16 TECHNICAL SPECIFICATIONS

This chapter of the safety evaluation report (SER) documents the U.S. Nuclear Regulatory Commission (NRC) staff's (hereinafter referred to as the staff) review of Revision 2 of the NuScale Power, LLC (hereinafter referred to as NuScale or the applicant), Design Certification (DC) Application (DCA), Part 2, "Final Safety Analysis Report (FSAR)," Tier 2, Chapter 16, "Technical Specifications," and the referenced proposed generic technical specifications (GTS) and associated GTS Bases in DCA Part 4. Together these portions of the DCA constitute the information related to technical specifications (TS) in the NuScale DCA.

LCO 3.7.2 Condition A. One or two FWIVs inoperable. (72 hours to isolate FWIV flow path or restore FWIV.)
 (Actions table Note 1, "Separate Condition entry is allowed for each inoperable valve.")

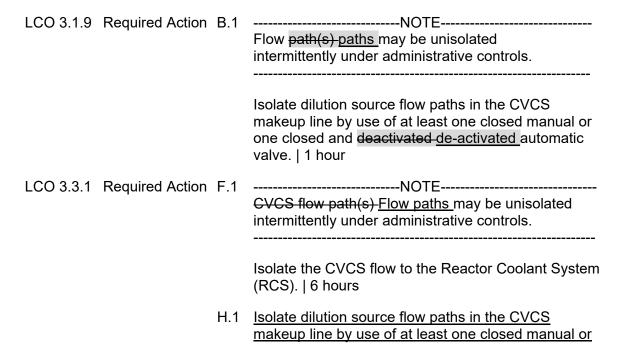
Condition B. One or two FWRVs inoperable. (72 hours to isolate FWRV flow path or restore FWRV.)

(Actions table Note 1, "Separate Condition entry is allowed for each inoperable valve.")

The staff finds that the restoration actions and remedial actions, and the associated Completion Times for the loss of redundancy Conditions are appropriate for the NuScale design, provide an adequate level of safety during operation within each Condition, and are consistent with STS. Therefore, the staff concludes that these Actions are acceptable.

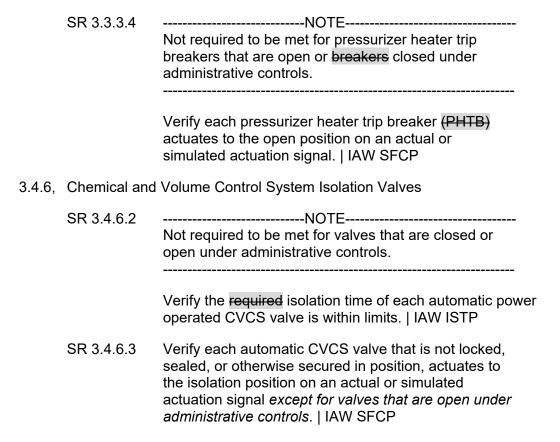
3.3.2,	Reactor Trip System Logic and Actuation		
	SR 3.3.2.1	.1	
	SK 3.3.2.1	Not required to be met for reactor trip breakers that are open.	
		Perform ACTUATION LOGIC TEST. IAW SFCP	
	SR 3.3.2.2	Not required to be met for reactor trip breakers (RTBs) that are open.	
		Verify required response time is within limits. IAW SFCP	
	SR 3.3.2.3	Not required to be met for Class 1E isolation devices that have isolated 1E circuits from non-1E power.	
		Perform CHANNEL CALIBRATION on each required Class 1E isolation device. IAW SFCP	
	SR 3.3.2.4	Not required to be met for reactor trip breakers that are open.	
		Verify each RTB actuates to the open position on an actual or simulated actuation signal. IAW SFCP

3.3.3,	Engineered S	afety Feature Actuation System Logic and Actuation	
	SR 3.3.3.2	Not required to be met for pressurizer heater trip breakers that are open or closed under manual control administrative controls.	
		Verify required pressurizer heater trip breaker response time is within limits. IAW SFCP	
	SR 3.3.3.3	Not required to be met for Class 1E isolation devices that have isolated 1E circuits from non-1E power.	
		Perform CHANNEL CALIBRATION on each required Class 1E isolation device. IAW SFCP

Subsection 5.6.3, CORE OPERATING LIMITS REPORT (COLR)

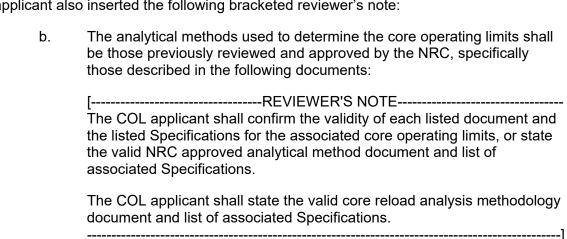
In RAI 472-9445 (ML18130A984), Question 16-43, the staff requested that the applicant revise Subsection 5.6.3, paragraph b, by listing the documents describing analytical methods previously reviewed and approved by the NRC and used to determine the core operating limits. In its response (ML18163A417) to RAI 472-9445, Question 16-43, the applicant inserted this list in paragraph b with brackets to indicate the list is a COL action item. Along with this bracketed list, the applicant also inserted the following bracketed reviewer's note:

Each document is listed by title, revision number, and date along with the LCOs supported by the analytical methods described in the document. The proposed change to paragraph b is consistent with the W-AP1000-STS presentation regarding level of detail and format. SER Section 4.3 gives the staff's evaluation of the listed methodologies. The staff verified that the response's listed methodologies and associated LCOs accurately cite the FSAR sections and topical reports provided in DCA Part 2. And Specification 5.6.3 encloses these methodology references and associated LCOs within brackets to indicate their designation as COL action items. The staff confirmed that the cited topical reports and FSAR references match Revision 2 of the DCA. The staff also confirmed incorporation of this list in Specification 5.6.3 of Revision 2 of DCA Part 4. SER Section 4.3 gives the staff's evaluation of the cited methodologies on the reactor core design and operating limits. Based on the applicant's response and incorporation of the methodology list in Specification 5.6.3, RAI 472-9445, Question 16-43 is resolved and closed.
